ADDENDUM # 08 JANUARY 27, 2012

# ADDENDUM 08 TO PLANS AND CONTRACT DOCUMENTS

# RIVERINE SAND MINING / SCOFIELD ISLAND RESTORATION PROJECT (BA-40)

#### ADDENDUM 08 TO BID DOCUMENTS

RIVERINE SAND MINING / SCOFIELD ISLAND RESTORATION	ESTIMATED QUANTITIES & SUMMARY OF SUBMTTALS	
STATE PROJECT NUMBER: BA-40	COMMINITATION CODMITTALO	
FEDERAL PROJECT NUMBER: BA-40	DATE: AUGUST 2011	
APPROVED BY: MAURY CHATELLIER, P.E.	SHEET 3 OF 57

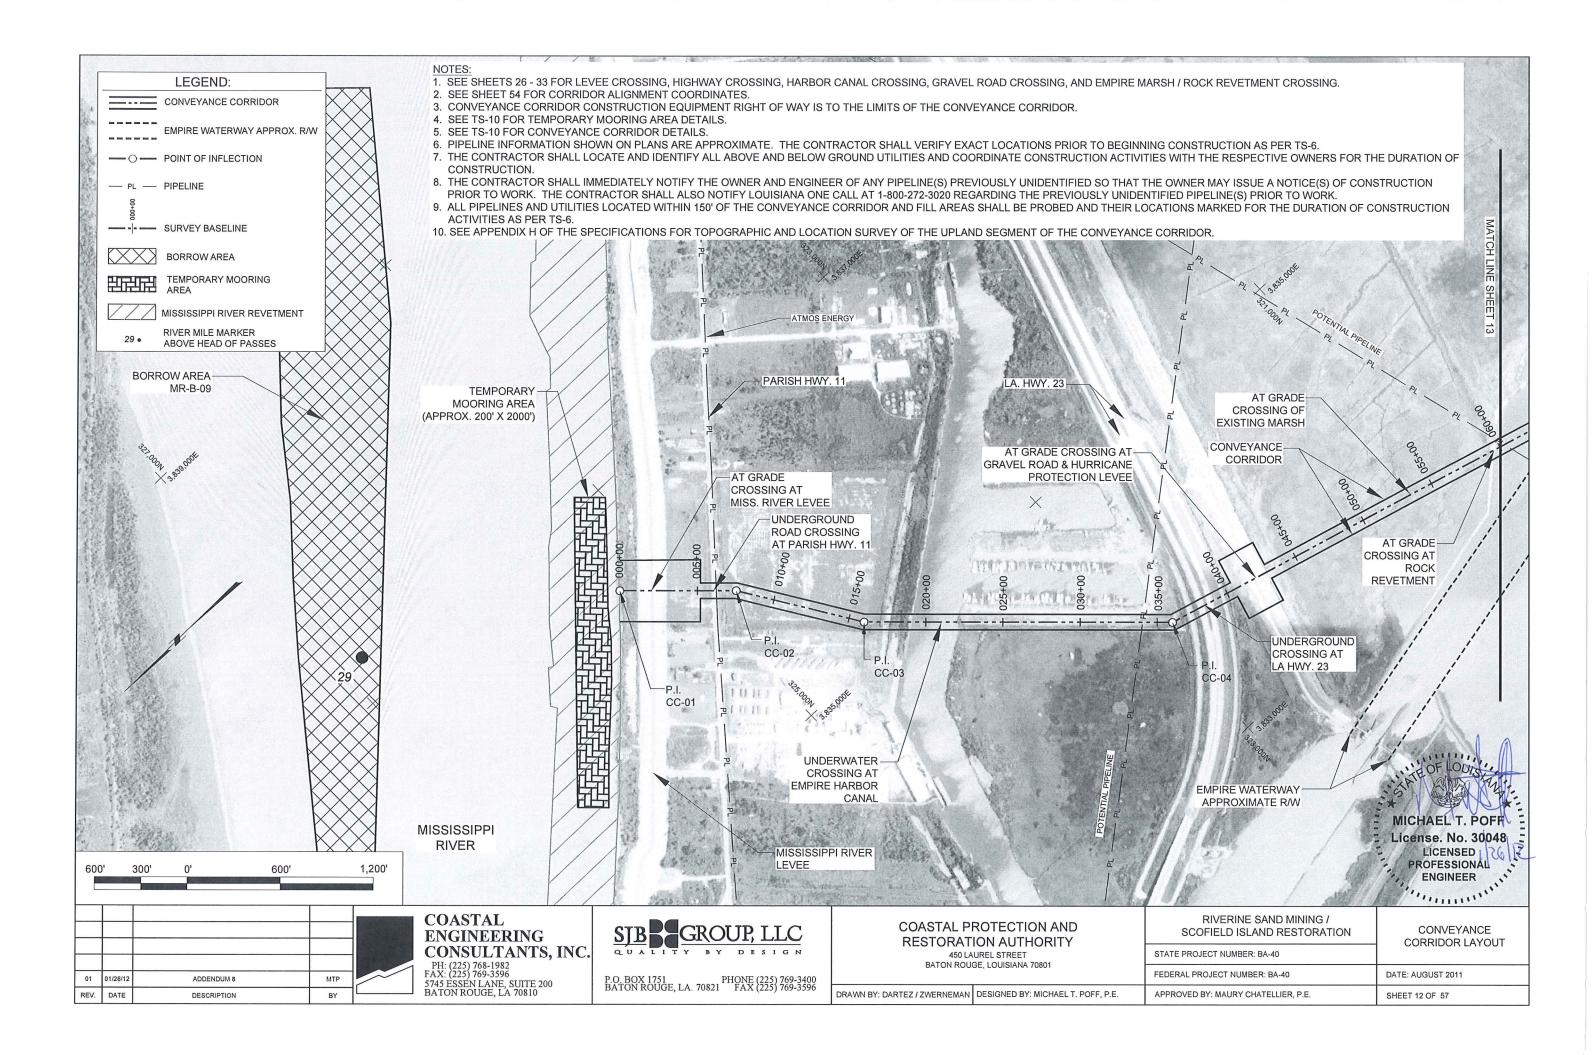
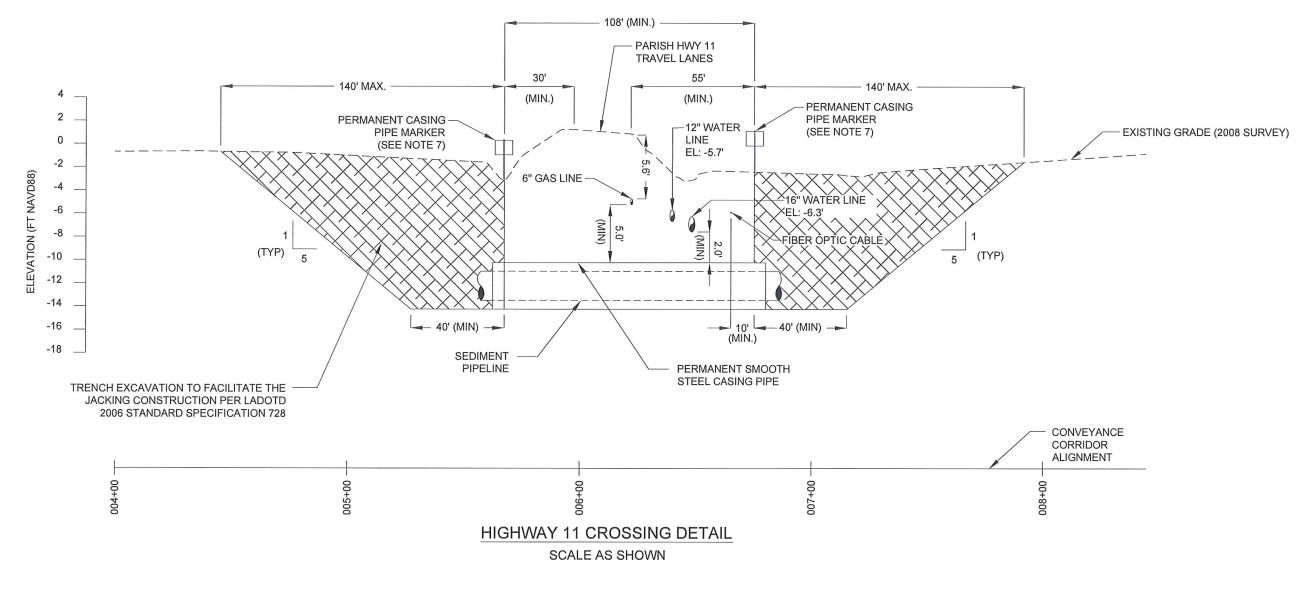
- 3.1 Sheet 3: Estimated Quantities and Summary of Submittals Revised Jacked Casing Pipe Estimated Quantity.
- 3.2 Sheet 12: Conveyance Corridor Layout Revised location of Atmos Energy Pipeline.
- 3.3 Sheet 27: Highway 11 Crossing Details Revised typical detail.
- 3.4 Sheet 30: Louisiana Highway 23 Crossing Detail Revised typical detail.
